DOLAN CONTRACTORS, INC.
GREEN MOUNTAIN BUSINESS PARK

P.O.A.D.P.

Re: Green Mountain Business Park POADP # 555

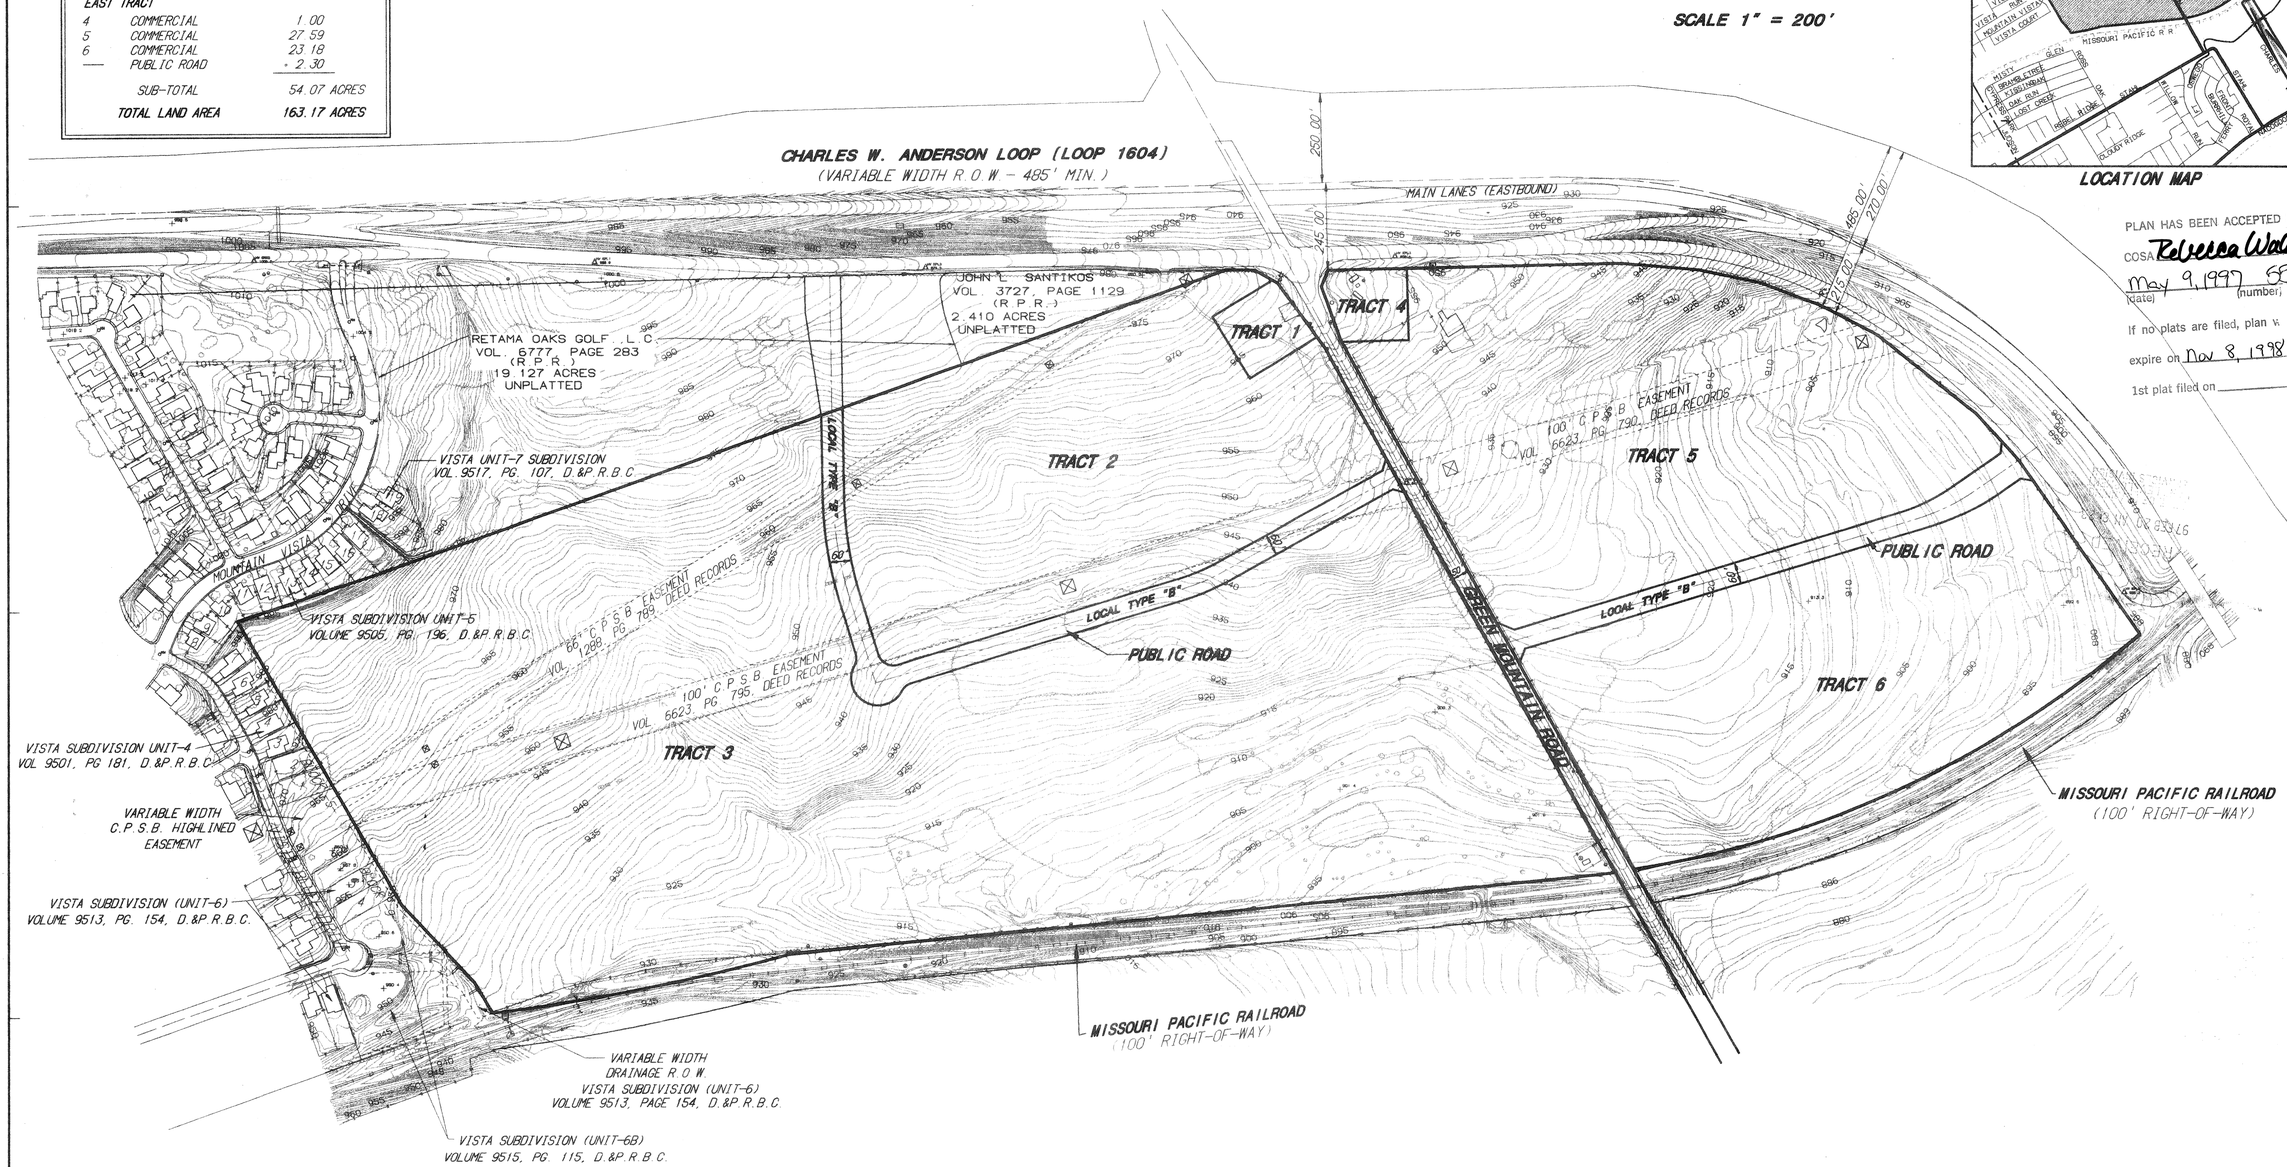
- Access and ROW issues along State facilities will need to be resolved with the Texas Department of Transportation (TXDOT). For additional information about these requirements you can contact TXDOT at 615-5814.
- Based on the topography, a Flood Plain Study and drainage review will probably be required during the platting process.
- If the proposed development is not platted in phases or units this POADP will not be valid.
- Green Mountain Road is a Secondary Type A Major Thoroughfare, and will require a total of 86' of ROW.
